TECHNICAL SERVICE BULLETIN

Technical Service Bulletin: 40-1044

2019 – BERKSHIRE CLASS A MOTORHOME – L.P. REGULATOR INSPECTION & REMEDY INSTRUCTIONS

FIGURE 1

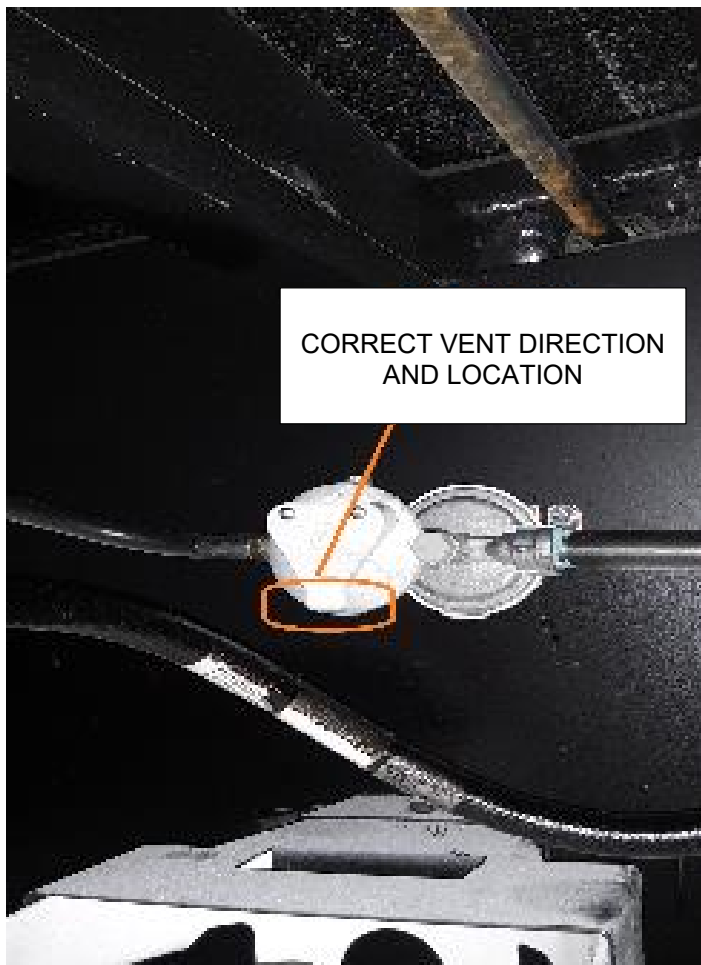
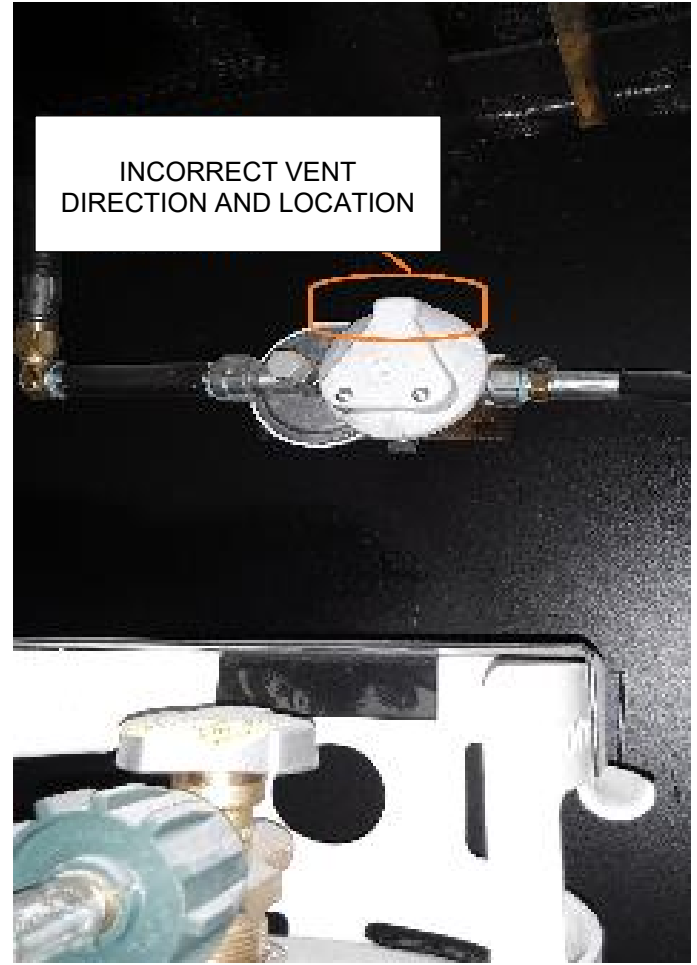
The L.P. Regulator was installed upside down in certain vehicles, which places the ventilation screen upward whereas it should be pointed downwards vertically. If the LP regulator vent screen remains vertically up, the vent may accumulate dust, dirt and/or other debris potentially causing poor performance of regulator ventilation affecting L.P. appliances connected to the exterior Quick Disconnect.

STEP 2: OBSERVE AND NOTE THE DIRECTION OF THE "TRIANGLE DIRECTION";

STEP 3: IF THE "TRIANGLE DIRECTION POINTS DOWNWARDS (FIGURE 1) **STOP** INSPECTION AND CLAIM REPAIR CODE LISTED ON THE NOTIFICATION FOR INSPECTION ONLY;

STEP 4: IF THE TRIANGLE DIRECTION POINTS UPWARDS (FIGURE 2), BEGIN REMEDY REPAIR;

STEP 5: REMOVE TWO RETAINING SCREWS FROM REGULATOR BASE;

STEP 6: ROTATE REGULATOR 180°, **IMPORTANT: DO NOT KINK ANY HOSE(S)**

STEP 7: ENSURE REGULATOR TRIANGLE POINTS DOWNWARD AND REFASTEN TO COMPARTMENT USING THE RETAINING SCREWS, SEE (FIGURE 1);
